UNITED STATES PATENT AND TRADEMARK OFFICE

Office Action Summary	Application No. 10/524,002	Applicant(s) DEMELLIER ET AL.	
	Examiner KEEGAN GUMBS	Art Unit 4128

DETAILED ACTION

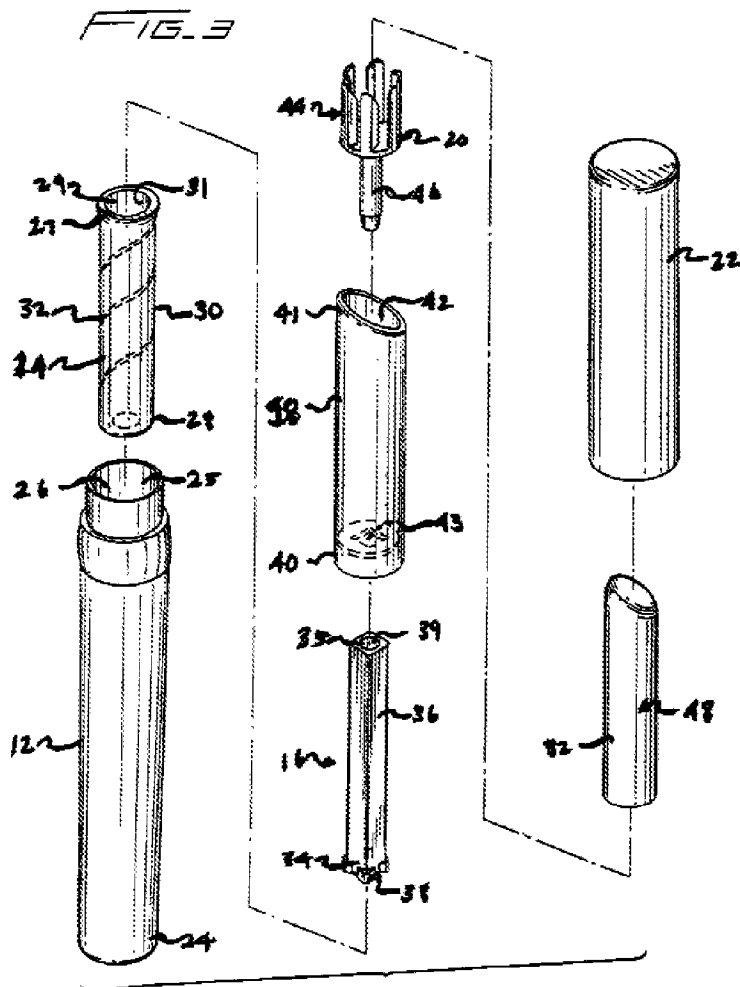
Regarding claim 1, the Bow reference discloses a cosmetic dispenser or rotating case comprising a base (12) mounted movably in axial rotation around a tubular body (18) in an interior of which is mounted a movable slide (20) which receives a product to be protected, the slide including a ballast (46) which augments the slides mass (*see the figure above*).

Regarding claim 2, the Bow reference discloses that the ballast is joined with the slide (*see the figure above*).

Regarding claim 3, the Bow reference discloses that the ballast is joined with an end of the slide which is situated under a space (44) designed to hold the protected product (*see the figure above*).

Regarding claim 4, the Bow reference discloses that the ballast is made of a high density material forming a single piece with the slide (*see the figure above and col. 5, lines 61-67*).

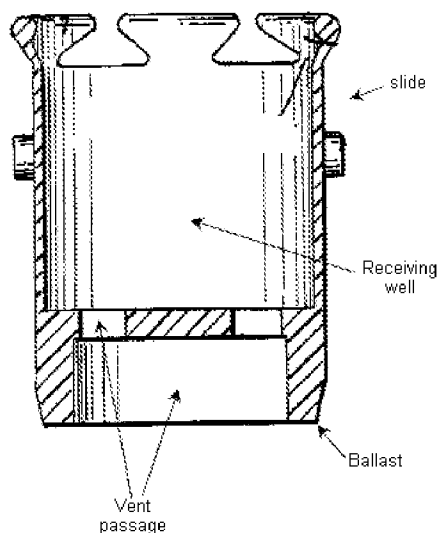
Regarding claim 13, the Bow reference discloses a lipstick or a lip balm container comprising a tubular body (18); a base (12), rotatably mounted to a lower end (40) of the tubular body; a slide (20) movably received in the tubular body, the slide defining a lipstick or lip balm receiving well (44) in an upper end and carrying a ballast (46) in a lower end; and a slide advancing mechanism (14) interconnected with the slide and the base such that the rotation of the base causes the slide to advance axially toward an

upper end (41) of the tubular body and opposite rotation of the base retracts the slide to the lower end of the tubular body (*see the figure above, col. 3, lines 45-67, and col. 4, lines 1-7*).

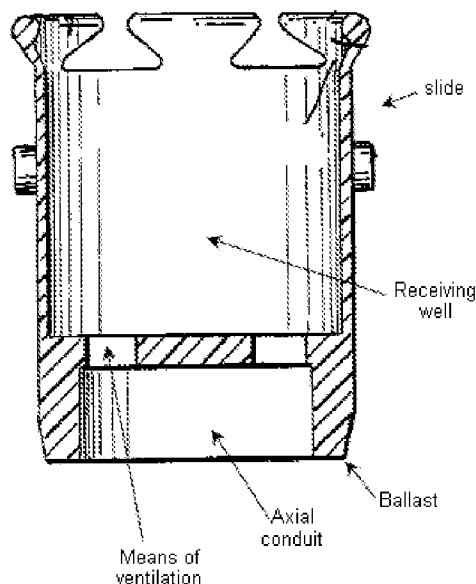
Regarding claim 16, the Sheffler reference discloses the receiving well which includes a vent passage extending from the lipstick or lip balm receiving well through the ballast to facilitate removal of air displaced by insertion of a lip stick or lip balm element into the lipstick or lip balm receiving well (*see the annotated figure above, col. 5, lines 4-11 and col. 8, lines 45-56*).

inserted into the slide, further including at least one axial conduit (*see the annotated figure below*) communicating with the space designed to receive the product and also with the space situated below the slide for venting the lower end of a product when the product is inserted into the slide (*see col. 5, lines 4-11 and col.8, lines 45-56*). It would have been obvious to one of ordinary skill in the art at the time the invention was made to have modified the slide of the Bow reference to include a means of ventilation for venting the lower end of the a product when the product is inserted into the slide, further including at least one axial conduit communicating with the space designed to receive the product and also with the space situated below the slide for venting the lower end of a product when the product is inserted into the slide in view of the Sheffler reference. Such modification would permit air to bleed through the bottom of the sleeve when a product is inserted into the sleeve for easy insertion of the product.
